DESIGN REVIEW/CERTIFICATE OF APPROPRIATENESS

Project/Property Address or Location: 475/485 Rocky Fork Blvd., Gahanna, OH 43230		Project Name/Business Name Mifflin Fire, Education/Admin Building	
Parcel ID No.(s): 025-003870, 025-006927	Zoning Designation: RID	Total Acreage: 1.76	
Please check all that apply:			
SITE PLAN <input checked="" type="checkbox"/>	LANDSCAPING <input type="checkbox"/>	BUILDING DESIGN <input type="checkbox"/>	DEMOLITION <small>only applicable to Code Chapter 1150, Olde Gahanna</small> <input type="checkbox"/>
OTHER <input type="checkbox"/>			
Project Description: Relocation of existing parking to serve the adjacent buildings on 475 and 485. Reconstruction of the existing drive to reduce "bottoming out" that has been occurring. Addition of new side door to apparatus bays to reduce opening and closing of garage doors.			
APPLICANT Name -do <u>not</u> use a business name: Nancy White		Applicant Address: 155 Olde Ridenour Road, Gahanna, OH 43230

Station 131
Concrete Repair
 475 Rocky Fork Blvd.
 Gahanna, Ohio 43230
 for
 Mifflin Township

PLANNING AND DEVELOPMENT STAFF REPORT

PROJECT LAYOUT PLAN
C201

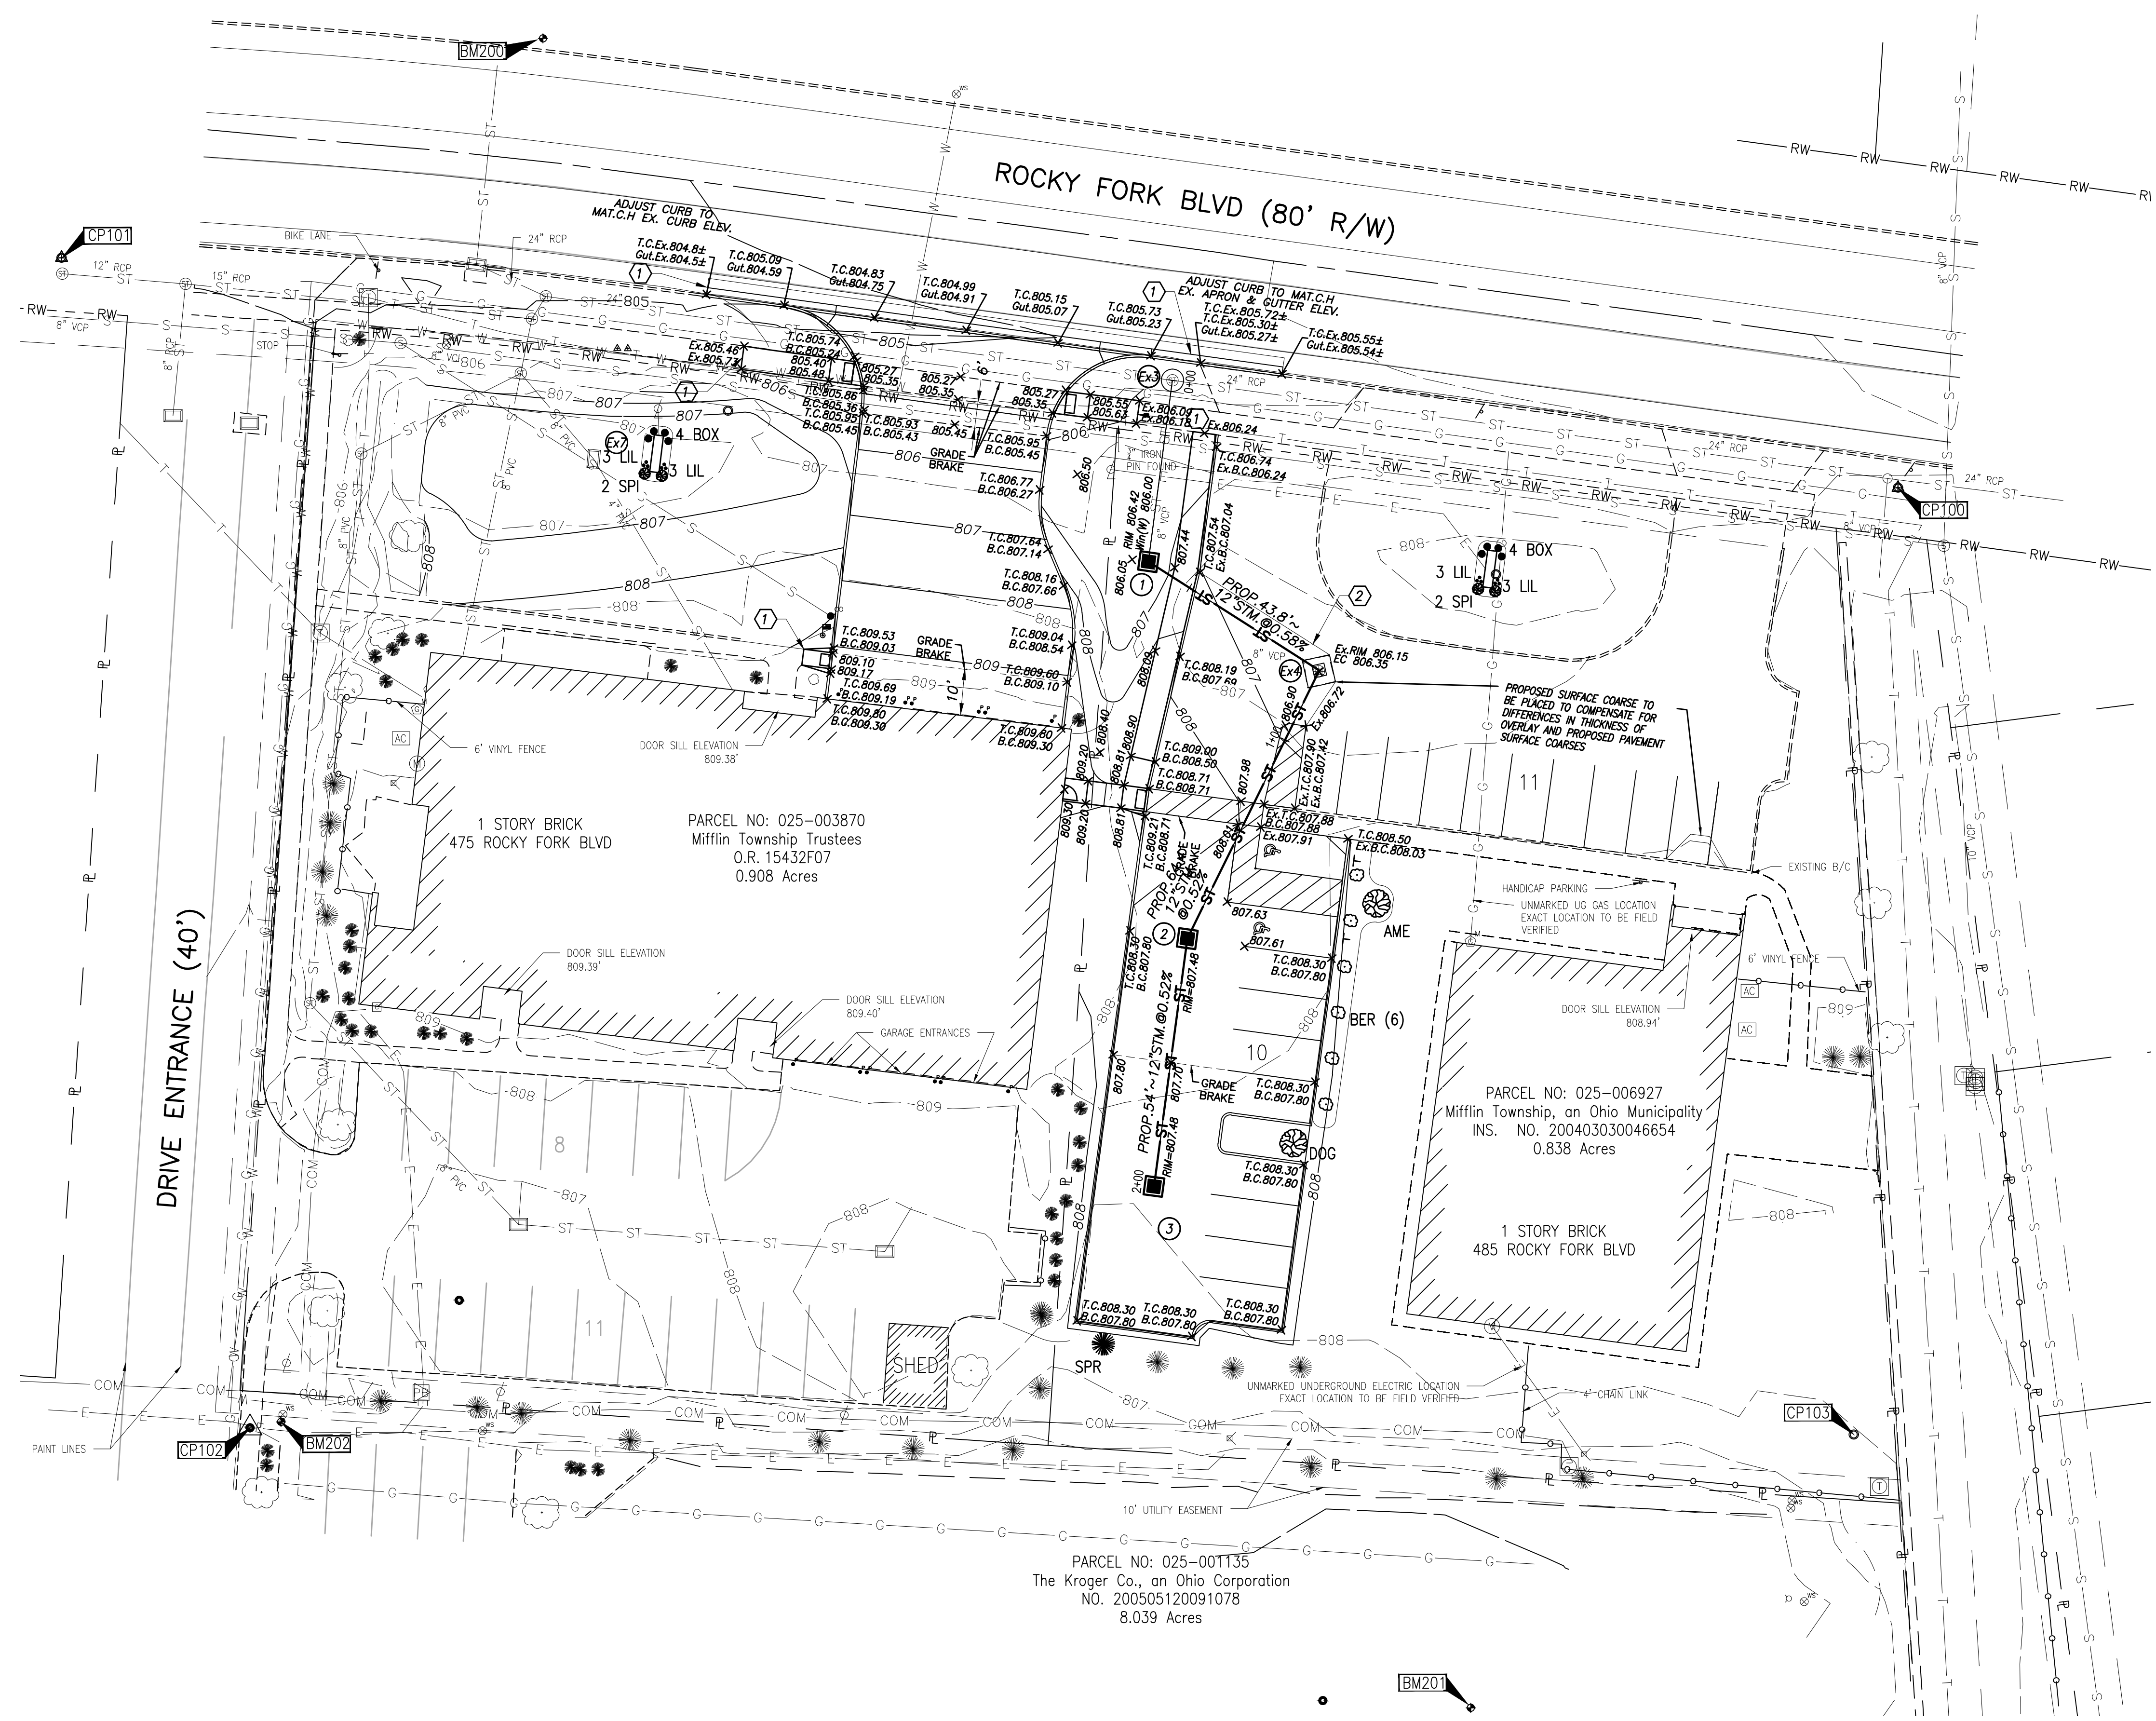
3. Chapter 1163.08(c) requires landscaping based on the total size of the parking lot. This would only affect 485 Rocky Fork since this parking lot is expanding. The code requires landscape islands equal to 5% of the total parking lot. One tree per 100 square feet of landscaping area is required. Please revise the plans accordingly. *Landscape islands will be added based on the area of the new parking lot.*

4. Chapter 1154.03(a)(7) requires parking areas to be setback a minimum of 15'. The new parking at 485 Rocky Fork appears to be located within the required setback. The site needs to be revised accordingly, a variance requested, or the two properties combined. Staff has no objections to a variance. *Per 1123.45 Parking space is defined as "the required for parking one automobile, not including passageways." The parking spaces for this development are on the other side of the drive aisle (passageway) there we meet the required 15' setback.*
